RE: Turkey Point Units 3 and 4
Docket Nos. 50-250 and 50-251
Homestead AFB Property Disposal

Re: Turkey Point Units 3 and 4
Docket Nos. 50-250 and 50-251
Response to Request for Information
Regarding the Impact of a Commercial Airport
at Homestead Air Force Base Site on Safety
at Turkey Point Units 3 and 4

**RISK ASSESSMENT OF THE
TURKEY POINT UNITS 3 AND 4 NUCLEAR POWER PLANT
FROM AIRCRAFT OPERATIONS AT THE
MIAMI-DADE COUNTY HOMESTEAD REGIONAL AIRPORT**

AERIAL PHOTO

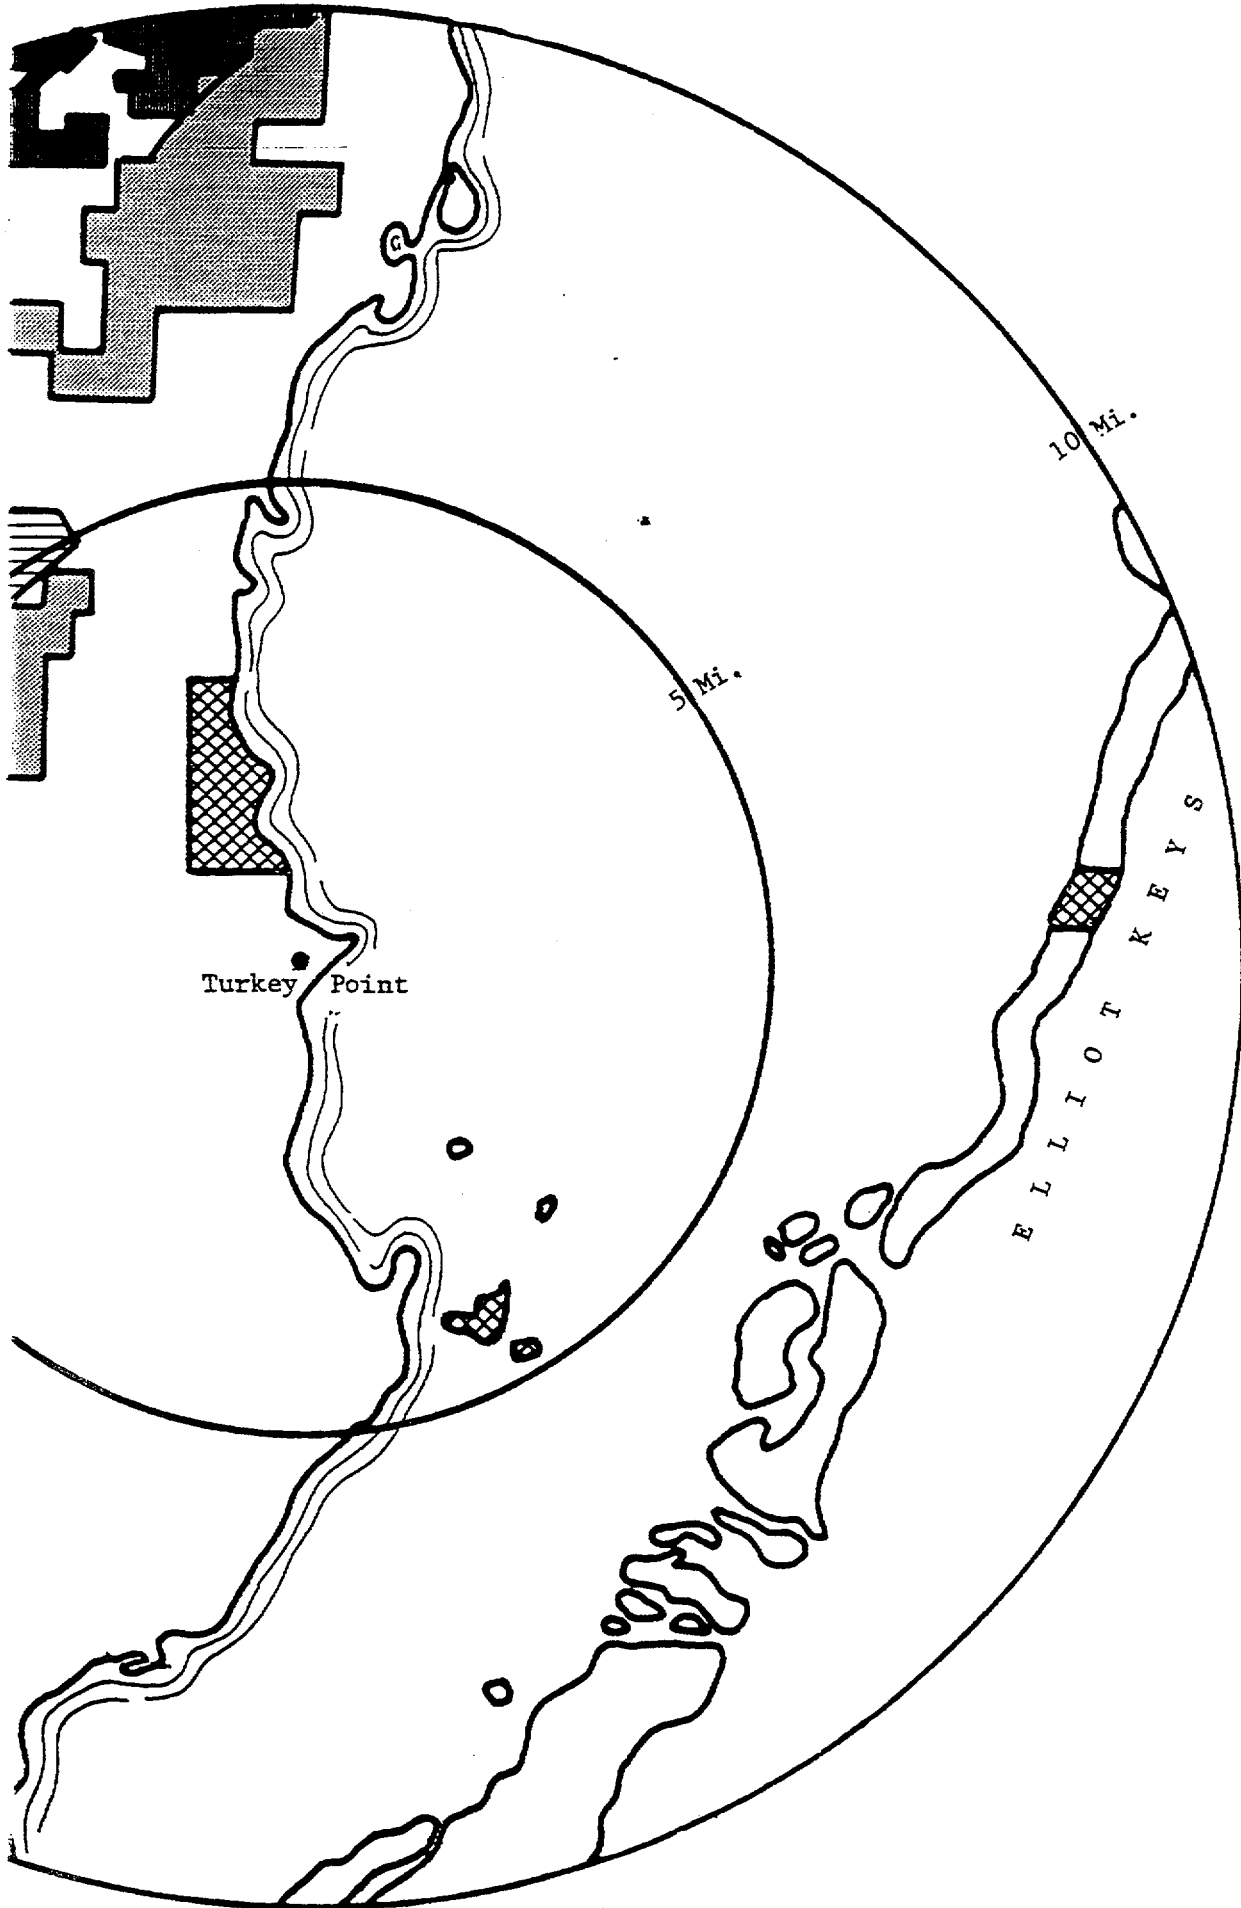
4. In the Turkey Point Final Safety Analysis Report (ref. 6, fig. 2.2-2, fig. 2.5-1, fig. 2.5-2), the relevant aerial photograph, maps, and diagrams appear to show that portions of Homestead Air Force Base lie within a 5 mile radius of the plant. How does this meet acceptance criteria II.1.a and II.1.b of NUREG-0800 (ref. 3, p 3.5.1.6-2) ?
